To: T10 Technical Committee
From: Rob Elliott, HP (elliott@hp.com)
Date: 18 January 2005
Subject: 04-340r2 SAS-1.1 OPEN_REJECT BAD DESTINATION handling

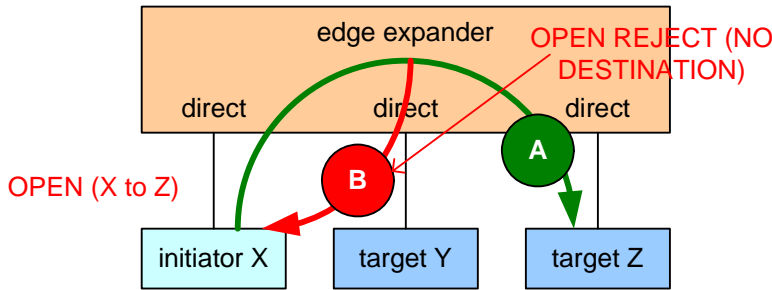
When the physical link to a destination SAS address goes down, the response can be either OPEN_REJECT (NO DESTINATION) or OPEN_REJECT (BAD DESTINATION) depending on whether there is a subtractive port in one of the expanders (see figure).

OPEN_REJECT (NO DESTINATION) is in the retry class of responses, meaning the OPEN will be attempted again until the I_T nexus loss timer expires. OPEN_REJECT (BAD DESTINATION) is in the abandon class, meaning the OPEN is not reattempted.

Since the physical link might become enabled again, the retry behavior is appropriate.

This revision proposes option a). Since this is handled in hardware by all existing expanders, it is only proposed as a "should".

With no subtractive port:

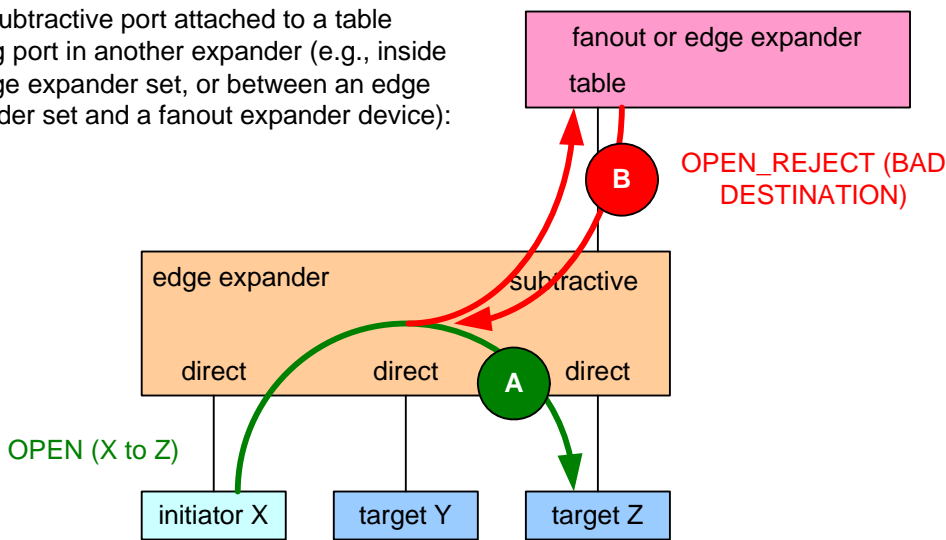
- A) before target physical link goes offline, OPEN routed to target
- B) after target physical link goes offline. OPEN_REJECT (NO DESTINATION) from edge expander

With subtractive port attached to a table routing port in another expander (e.g., inside an edge expander set, or between an edge expander set and a fanout expander device):

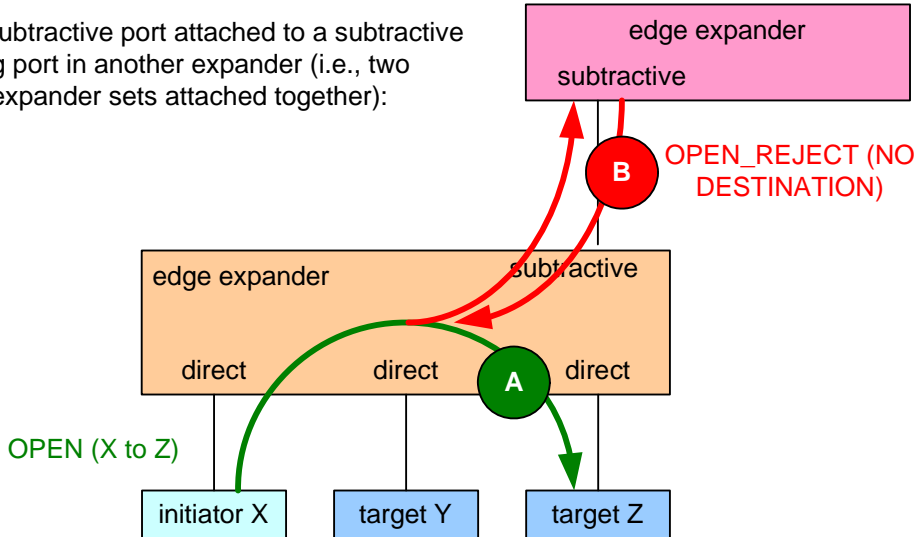
- A) before target physical link goes offline, OPENS routed to target
- B) after target physical link goes offline, OPEN_REJECT (BAD DESTINATION) from top expander
